**U.S. NUCLEAR REGULATORY COMMISSION**  
 In the Matter of AmerGen Energy Co., LLC  
 Docket No. 50-0219-12 Official Exhibit No. Citizens Exhib 13  
 OFFERED by: Applicant/Licensee Intervenor  
 NRC Staff                      Other                       
 IDENTIFIED on 9/20/07 Witness/Panel N/A  
 Action Taken: ADMITTED REJECTED WITHDRAWN  
 Reporter/Clerk

**Memorandum**

**Subject: Review of Fitness for Service Assessment of Oyster Creek Dry Well  
on the Basis of Extended Data Analysis**

Figure 1

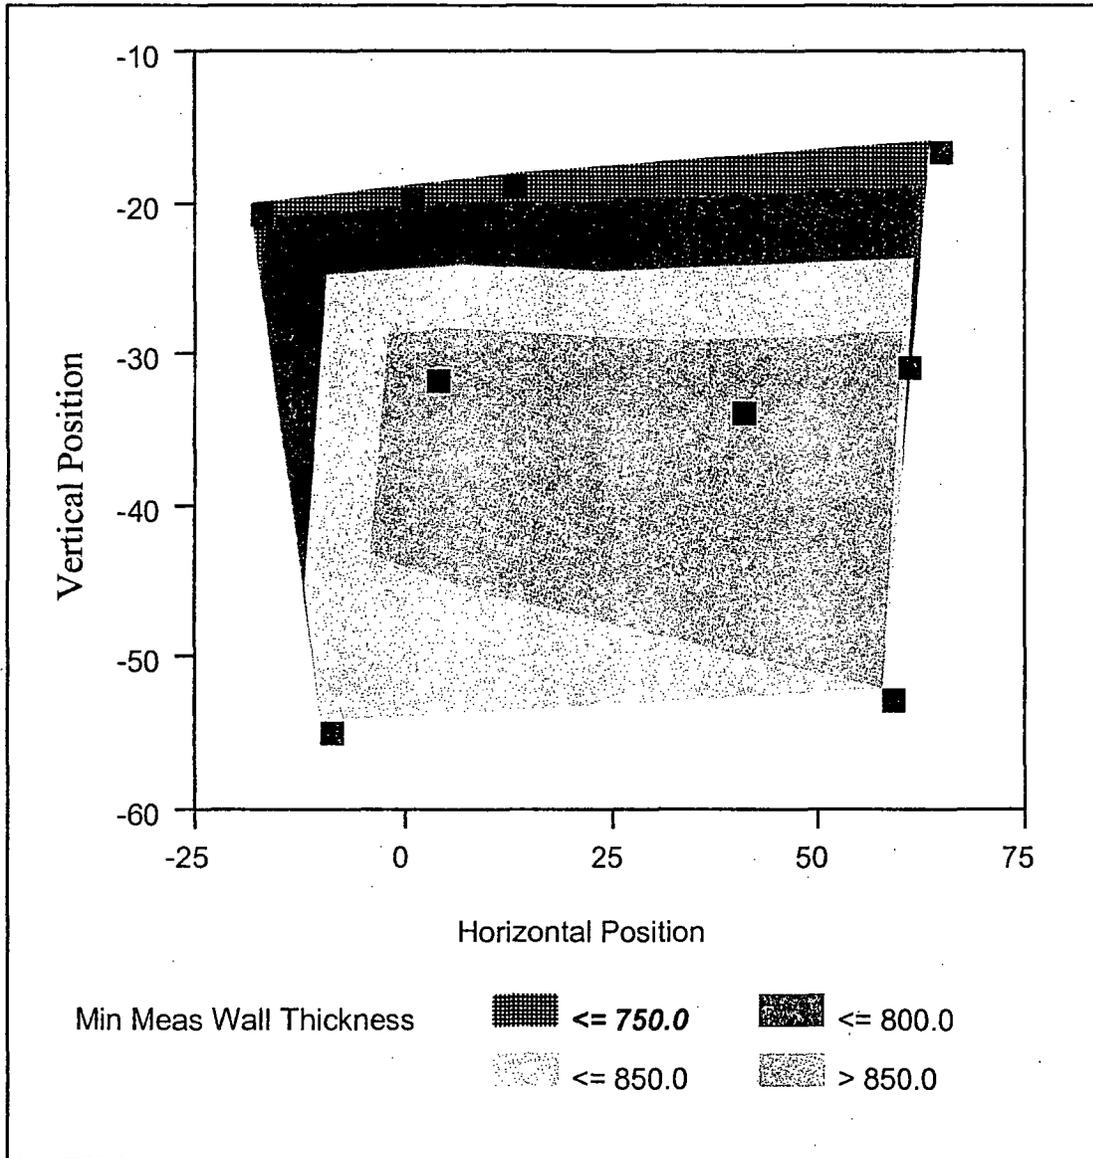
possible. However, we can look at the situation and gain intuitive insight into this question. Figure 1, which is discussed in detail below, presents areas of equal wall thickness (contours) based on the measurements, shown as the points, performed on the outside of Bay 19 in 2006. Note the dark squares are 2.5 inch on each side (and drawn to scale with reference to the horizontal axis), hence cover the area of measurement claimed by AmerGen. It turns out that the measurements at the -20 (inch) vertical position are on average less than 0.725 inches. Since measurements had not been extended to higher elevations one has no assurance that there are no more seriously corroded areas either between those measured or further up in the sandbed.

The advantage of this evaluation is that one can see all the available data in a quantitative presentation. Thus, one can see in Figure 1 that an area exists at elevation -20 (20 inches below the reference point) where the remaining wall thickness is less than 750 mils, or less than the criteria for general thinning at 95% confidence. This area extends from 20 inches on the left (-20 inches) to about 60 inches on the right (+60 inches), or about 7 feet. The width of this area in Fig. 1 is maybe 4 to 5 inches, however, because measurements were not extended toward lesser elevations (from the reference point) one simply cannot estimate how much further the serious the corrosion may extend in Bay 19.

**Figure 1** mentioned previously shows a heavily corroded area in Bay 19 at elevation  $-20$ . The extent of this area is highly uncertain because it was not further defined by additional UT measurements toward higher elevations ( $>-20$ ). Indeed, one could find here an extended bathtub ring area.

**Figure 2**  
**Bay 1 Remaining Wall thickness**  
**External UT Measurements 1992/1993**

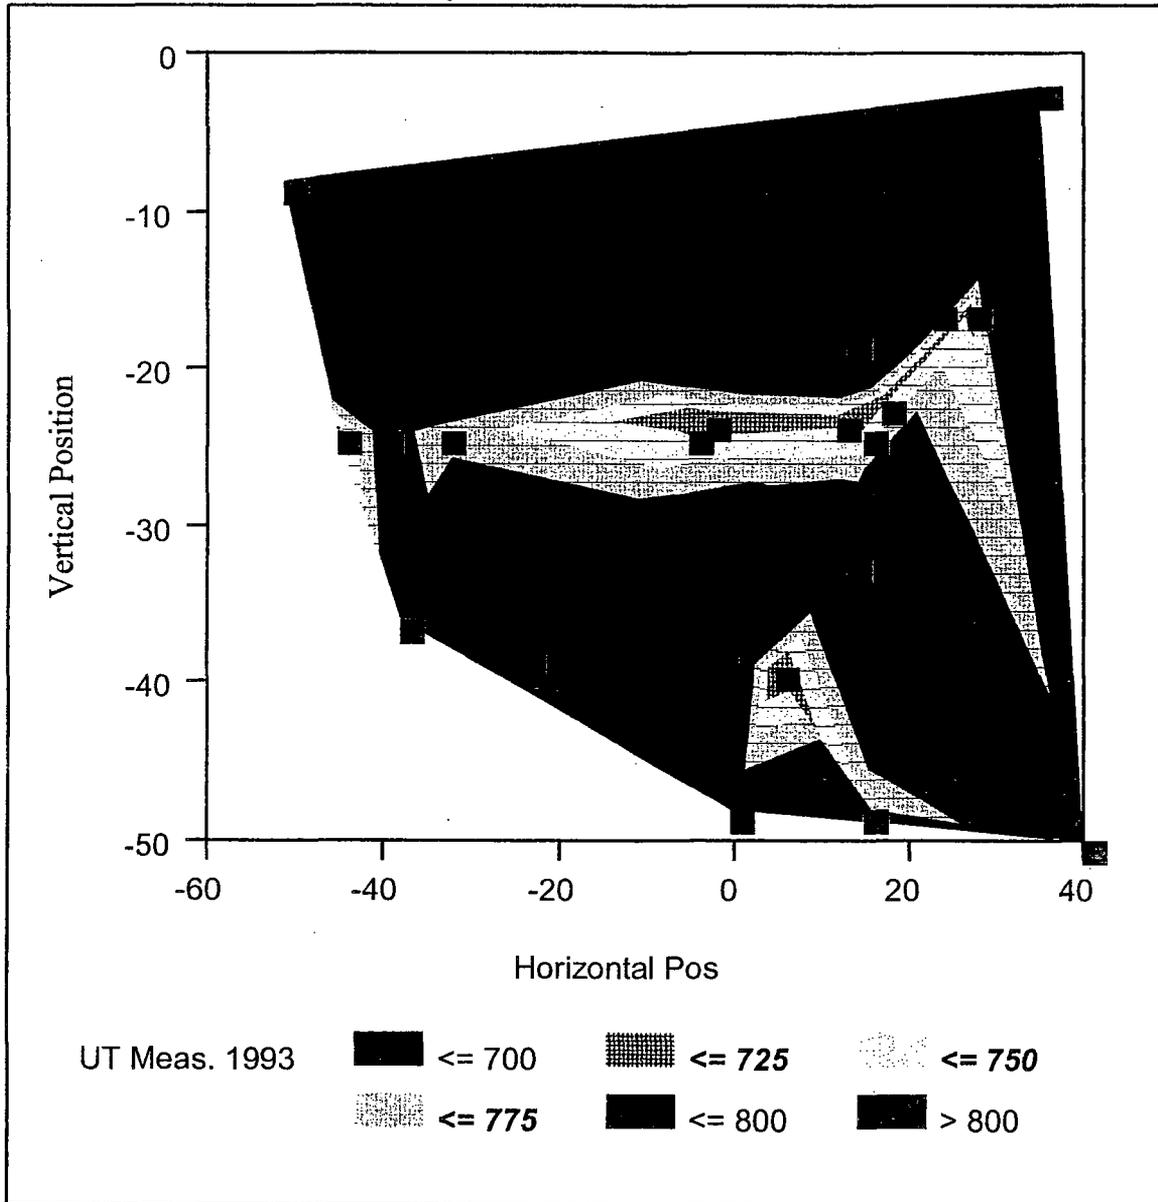
AmerGen discusses the bathtub ring in Bay 1 (See also Figure 2) as one single area using 1992 and 2006 data for which the *evaluation thicknesses* had been determined (See discussion of evaluation thicknesses above). AmerGen finds that in this area the average of 11 data points, which is around 4 square feet in area, is 0.766 inches and 0.765 inches for the 1992 and 2006 measurements, respectively. Considering the uncertainty of the measurements, +/- 27 mils, there is at least a 5% probability that the remaining margin is of the order of 2 to 3 mils, assuming that areas larger than one square foot in extent must average 0.736 inches or more.

The data used for the analysis are contained in Tables 1 and 2 for Bays 1 and 13 as extracted from AmerGen documents. Presumably, these were the most corroded Bays. Figure 2 shows a contour plot for Bay 1 obtained with the data from 1992. The dimensions of the points in the plot are 2.5 by 2.5 inches. Again, one needs to remember that the specific shape of the contours depends not only on the residual wall thickness measured at the locations indicated, but on the density of measurements as well. (For instance, an additional measurement at coordinates h (-20) v (-25) could completely alter the contours and in all likelihood extend the area of wall thickness below -750 mils <sup>4)</sup>).

Nevertheless, it appears in Figure 2 that in the so called “bathtub ring” an extensive area exists with wall thicknesses between 700 and 750 mils (0.75 inches). This area extends well over 52 inches (4+ feet) and is about 5 inches wide. In view of the fact that UT measurements are at best accurate with a standard deviation of about 45 mils, (95% confidence limits +/-90 mils), this area could well be more extensive.

Figure 3

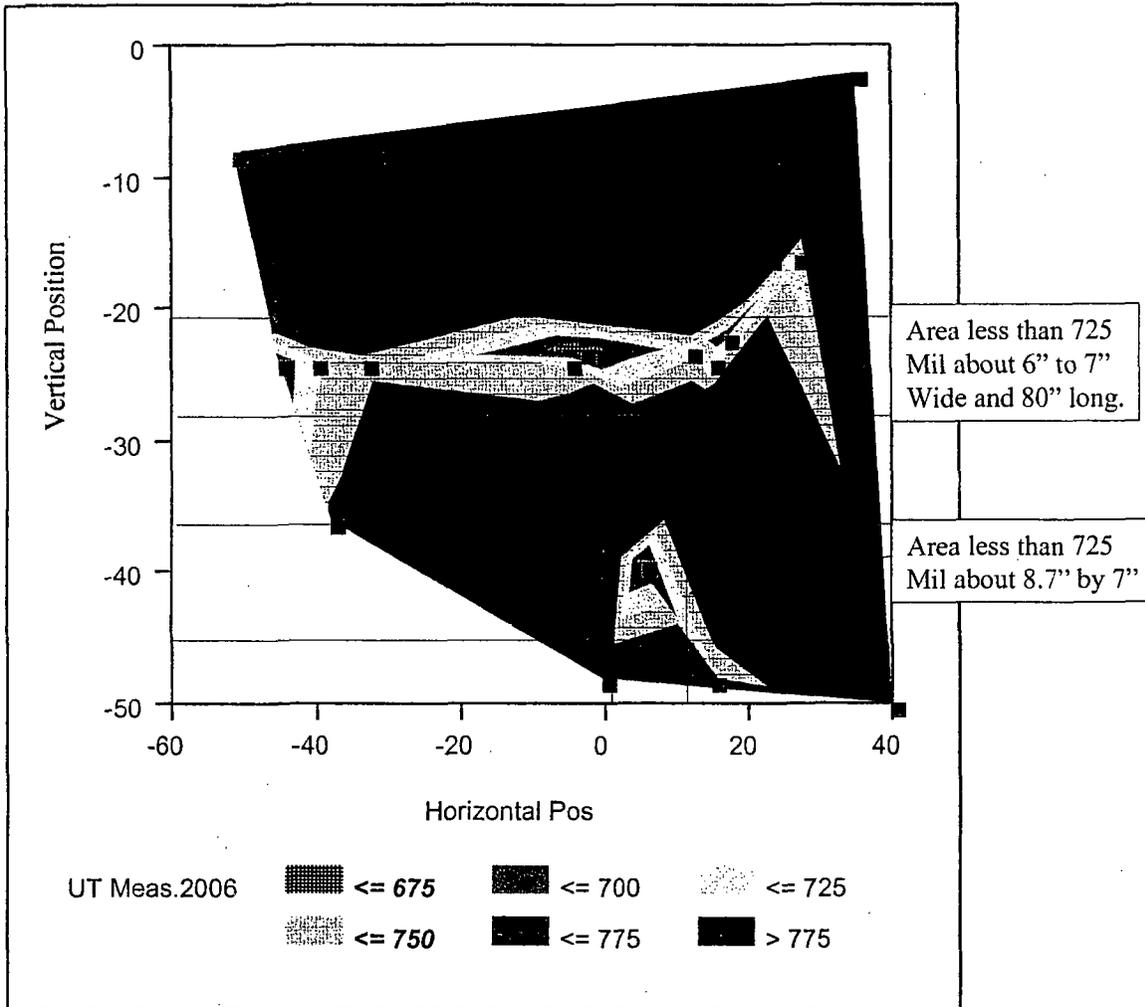
**Figure 3** shows the contours for Bay 1 obtained with the data from the 2006 inspection. The general shapes are the same as in Figure 2 except that here we have sizeable areas with residual wall thicknesses below 725 mils. The unexpected thing is

that these areas seem to extend on the left beyond  $-40$  inches but no measurements are available to verify whether AmerGen did in fact manage to capture all of the most corroded areas as claimed.

Based on Figure 3, together with an assessment of the accuracy (reliability) of the data one must conclude that there is a good likelihood that the entire bathtub ring area extending from  $40$  to  $-40$  inches on the horizontal axis and from about  $-30$  to perhaps  $-20$  inches on the vertical axis is below the  $0.736$  inch criteria for general thinning and is, much larger than the one square foot acceptance criterion. (Of course, since this area is the most corroded, it will taper off to higher wall thickness on both sides of the vertical axis). The corroded area is indeed shaped quite irregular, but one could venture a guess that the contoured areas below  $750$  mils are of the order of  $4$  to  $7$  square feet all together. This estimated area does not include the area to the left of  $-40$ , which probably contains additional area below  $0.750$  inches.

Figure 4

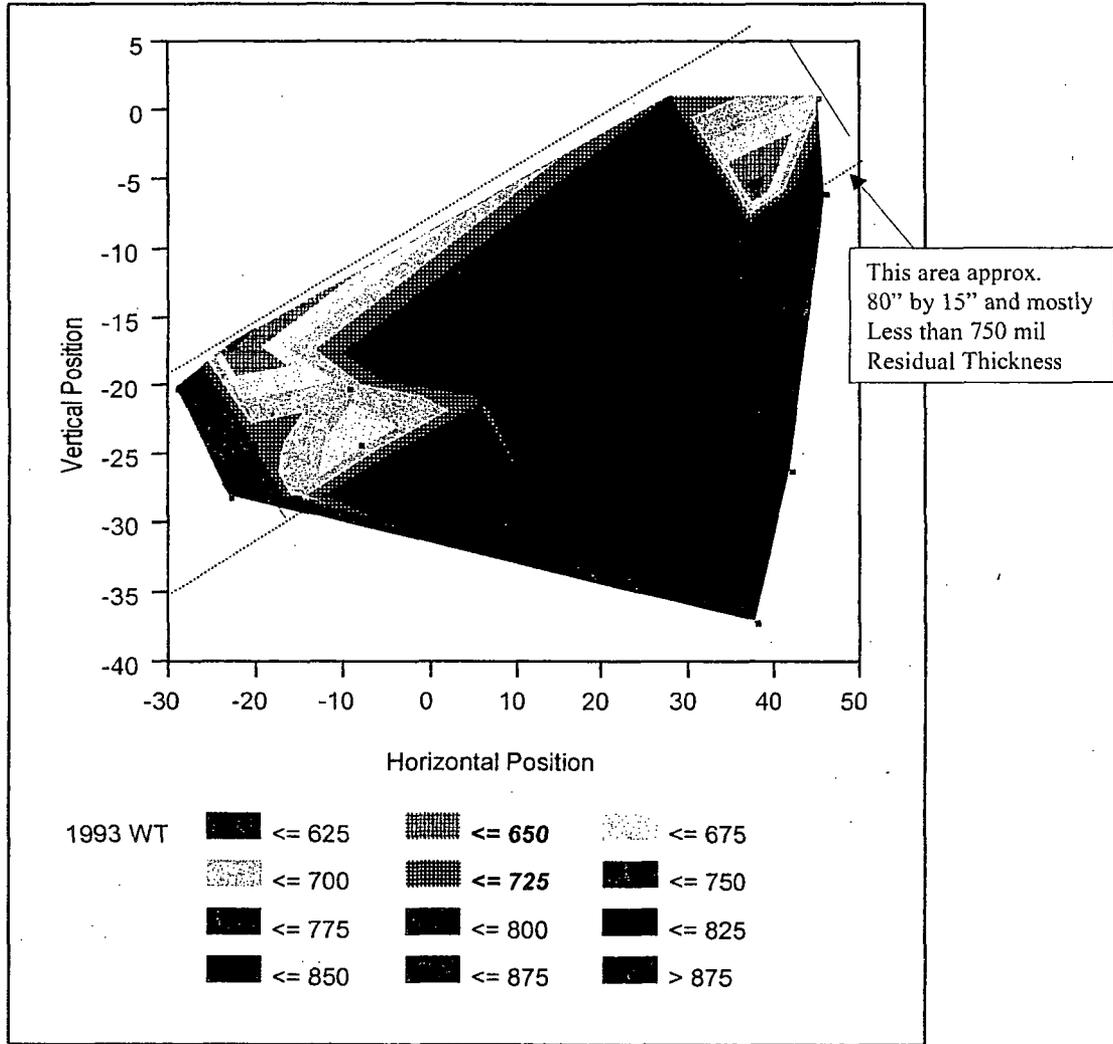
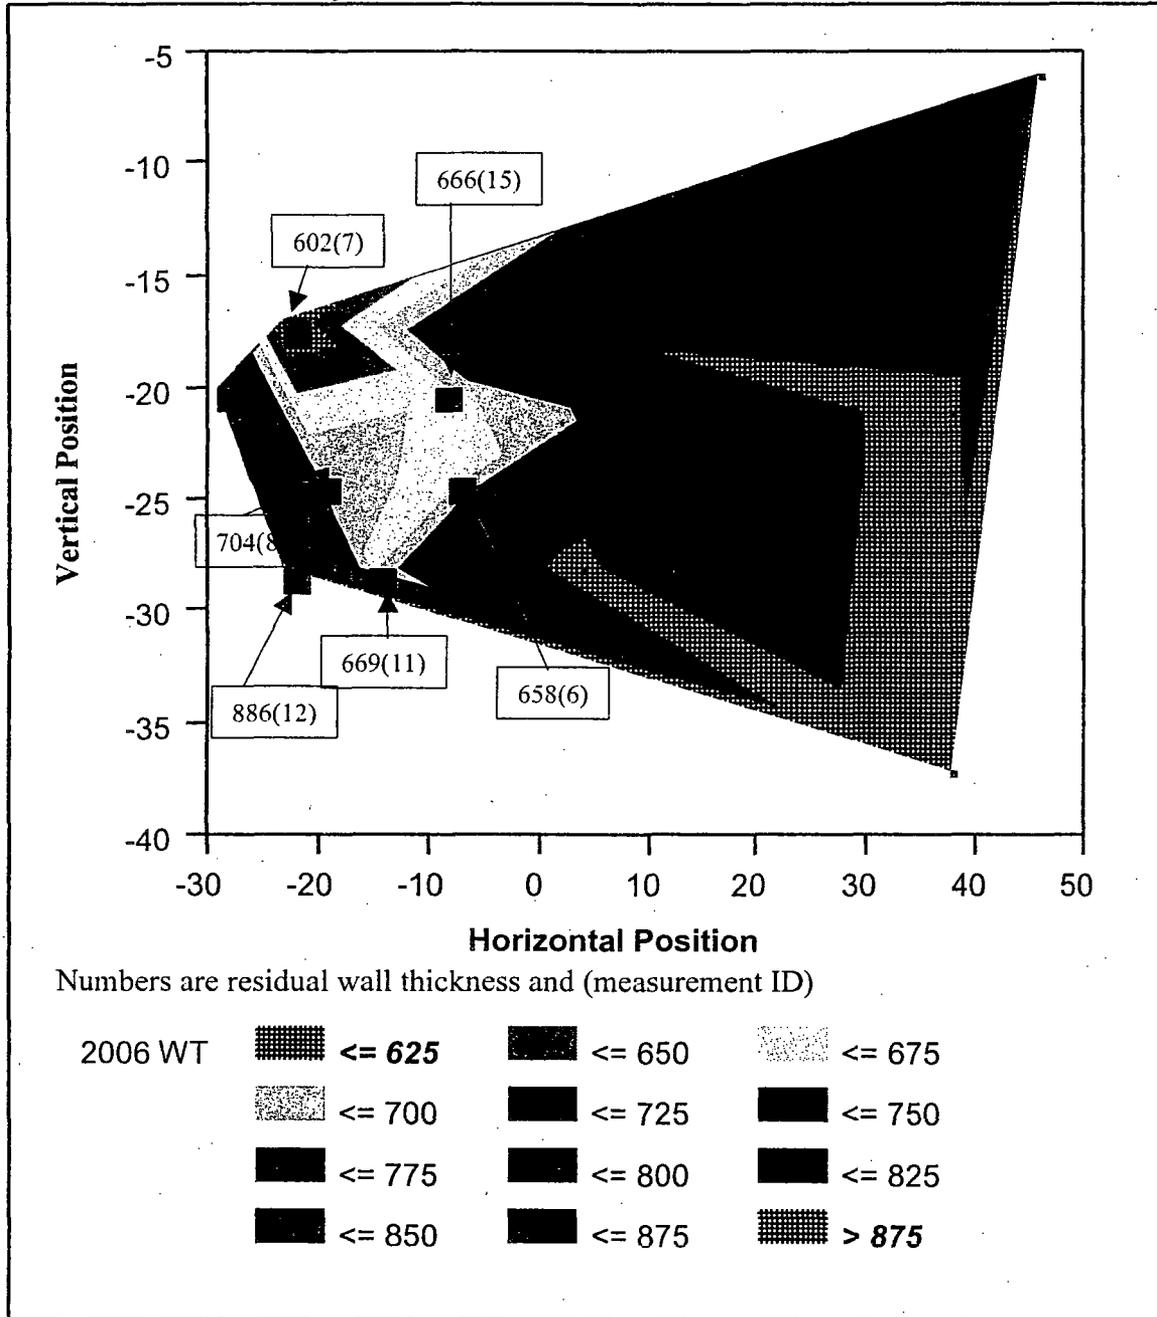
**Figures 4 and 5** show the contours for Bay 13, 1992 and 2006 data, respectively. Here large areas exist with wall thicknesses below  $700$  mils and at least two seemingly unconnected areas where the residual wall thickness is less than  $650$  mils. It could be argued that those heavily corroded areas are less than  $1$  square foot and therefore are still acceptable according to the  $636$  mil criterion. However, the heavily corroded area on the left hand side ( $-20, -20$ ) has not been further explored. One therefore does not know whether it might extend further. Similarly, the area on the right ( $(40, -7)$ ), clearly showing a fairly deep pit, was not further explored and was not even measured in 2006. While in Bay 1 the bathtub ring was at elevation  $-20$  to  $-25$  (from the reference point) in Bay 13 there is no clearly prominent bathtub ring. This may be because it was not there, but it may also be because the measurements were not extended toward elevation  $-15$  and  $-10$ . We are therefore left with a great uncertainty as to the true extension of the damage in this Bay.

- If an area is less than 0.736 inches thick then that area shall be greater than 0.693 inches thick, and shall be no larger than 6 inches by 6 inches. C-1302-187-5320-024 has previously placed an area of this magnitude in Bay 13 (Ref.2) <sup>5)</sup> Actually, as can be seen from Figure 4, there are two such areas in Bay 13.
- Most recently, the limiting wall thickness criterion was formulated as follows: *An evaluated area for local buckling shall not be greater than 36 inches by 36 inches wide. The center of the area shall be no larger than 12*

Figure 6

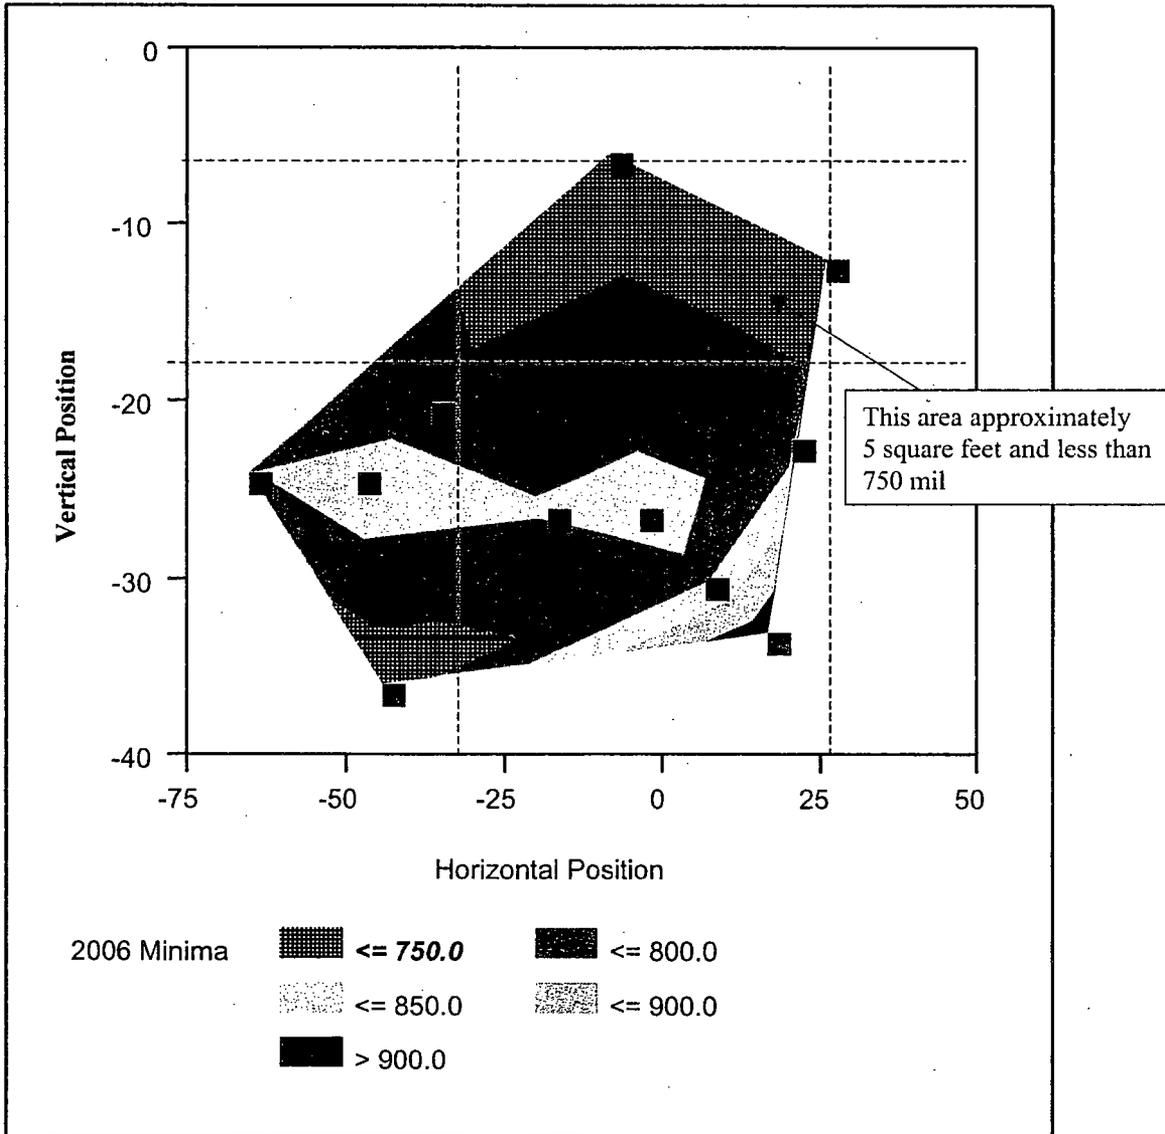
**Figure 6** shows the contours for Bay 15. There is a heavily corroded area at elevation  $-10$  with an extension of  $1$  ft by about  $4.5$  feet. However, this area was explored only with  $2$  measurements and was not extended beyond about  $2$  feet either side of the centerline. It appears that the majority of the measurements occurred in the non-corroded zones. Interestingly there appears some serious corrosion near the sandbed bottom, but the occurrence was not further explored either.

Figure 7  
 Contour Plot for External UT 1992 Data Bay 11

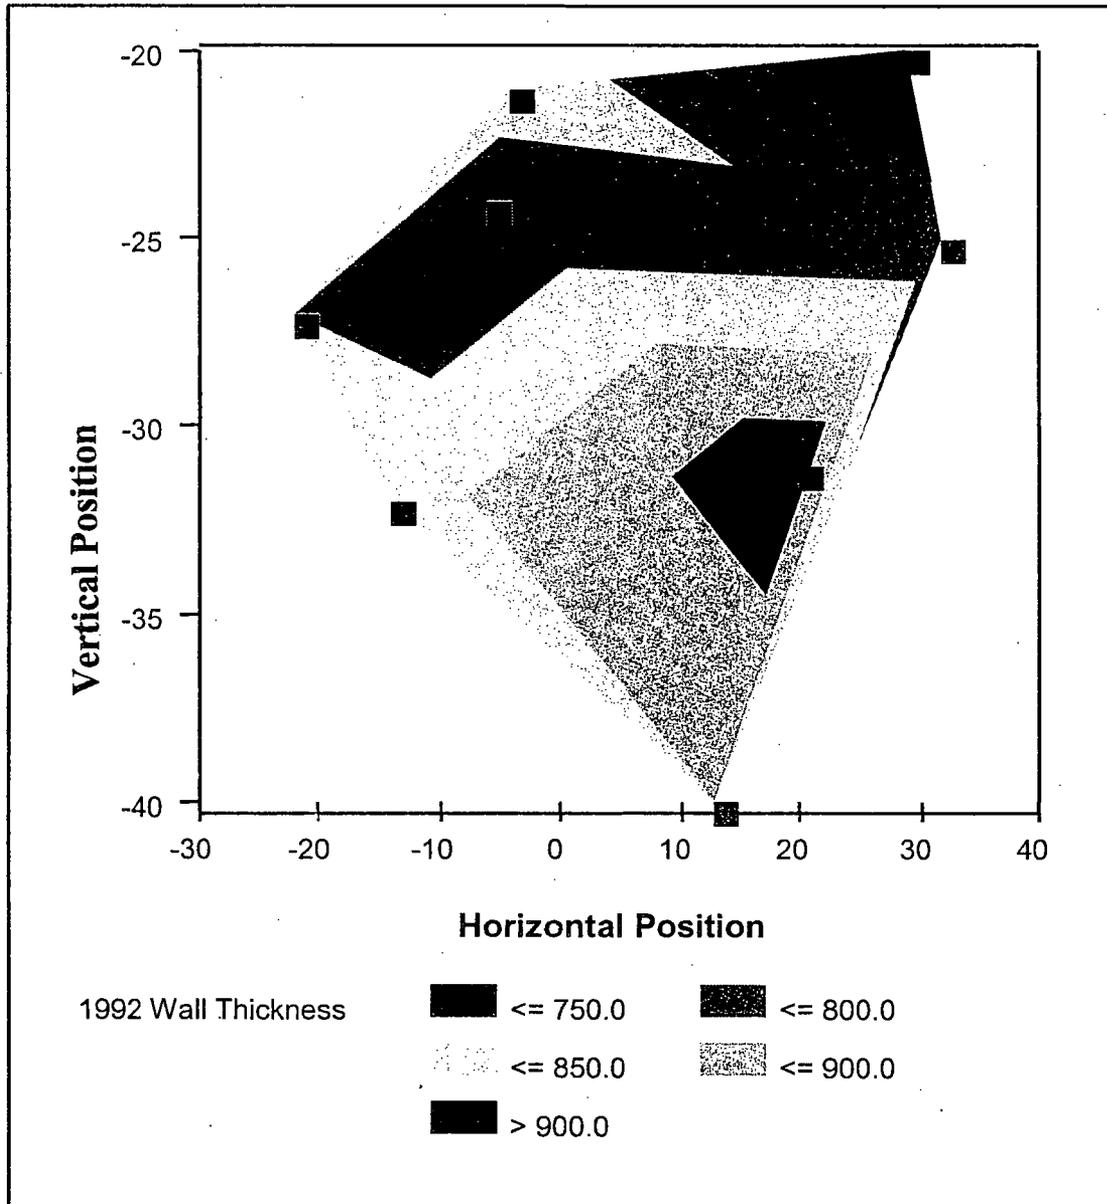
**Figure 7** shows the contours for Bay 11. Again there is a suggestion of severe corrosion at elevation  $-20$  and no further exploration into the bathtub ring area. Once again, the extent of this area is highly uncertain because it was not further defined by additional UT measurements.
